Access Compliance Report

Public Rights-of-Way

(Curb Ramps)

Intersection ID: 31679	Main Street: HOLLIFORD_CT	Cross Street: PHIL_ONEIL_DR	Location: SE
ADA ID: A667EAB53A07	Ramp Type: BlendTrans1	Initial Pass/Fail: Fail	Overall Compliance: No
Severity Score: 10			
Codes/Mitigation Info/Possible Solution		Field Measurements/Component Compliance

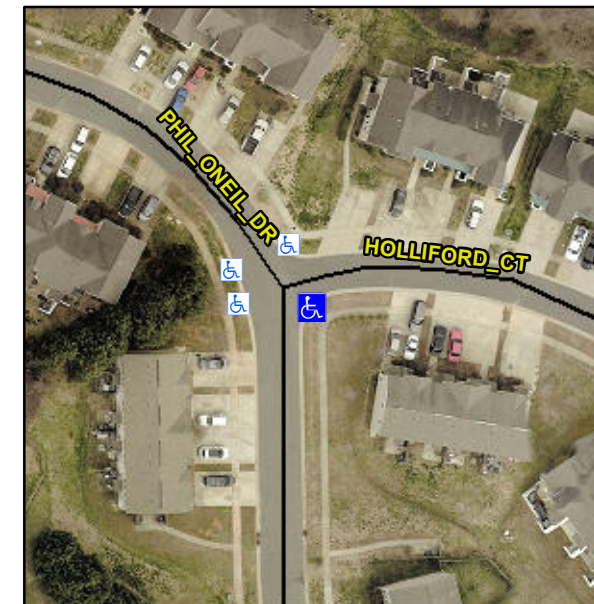
Not Found, R304.5.1, R304.5.3

Compliance	Description	Data	Compliance	Description	Data
N/A	Ramp Length (in)	98.0	Yes	BlendTrans Slope (%)	4.5
No	Ramp Width (in)	46.0	No	BlendTrans XSlope (%)	3.0
N/A	Flare Type LT	N/A	N/A	Flare Type RT	N/A
N/A	Flare Slope LT (%)	N/A	N/A	Flare Slope RT (%)	N/A
N/A	Flare Traversable LT?	N/A	N/A	Flare Traversable RT?	N/A
N/A	Landing Length (in)	N/A	N/A	DWS Provided?	N/A
N/A	Landing Width (in)	N/A	N/A	DWS Contrast?	N/A
N/A	Landing Slope (%)	N/A	N/A	DWS Length (in)	N/A
N/A	Landing X Slope (%)	N/A	N/A	DWS Full Width?	N/A
N/A	Landing Curb? (Y/N)	N/A	N/A	DWS Offset (in)	N/A
N/A	Shared Landing?	N/A			
N/A	Gutter Ponding?	N/A	N/A	Gutter Slope (%)	N/A
N/A	Gutter Lip Ht (in)	N/A	N/A	Gutter X Slope (%)	N/A
N/A	Painted X Walk1?	No	N/A	Painted X Walk2?	No
	X Walk 1 Direction	To NW		X Walk 2 Direction	To SW
	X Walk 1 Width (in)	N/A		X Walk 2 Width (in)	N/A
	X Walk 1 Slope (%)	4.7		X Walk 2 Slope (%)	6.3
	X Walk 1 X Slope (%)	2.8		X Walk 2 X Slope (%)	3.0

N/A	Ramp inside XWalk1?	N/A	N/A	Ramp inside XWalk2?	N/A
	Road Slope (%)	0.9		Clear Space?	N/A
	Road X Slope (%)	5.4	N/A	Clear Space to XWalk (in)	N/A
N/A	Any Obstructions?	N/A	N/A	Storm Grate/Utility Hazard?	N/A
	Obstruction Type			Storm Grate/Utility Type	
		N/A			N/A
			Yes	Surface Condition? (G/P)	Good
			No	Curb Slope (%)	7.5

Remove & Replace Curb Ramp With Two New Directional Ramps or Equivalent.
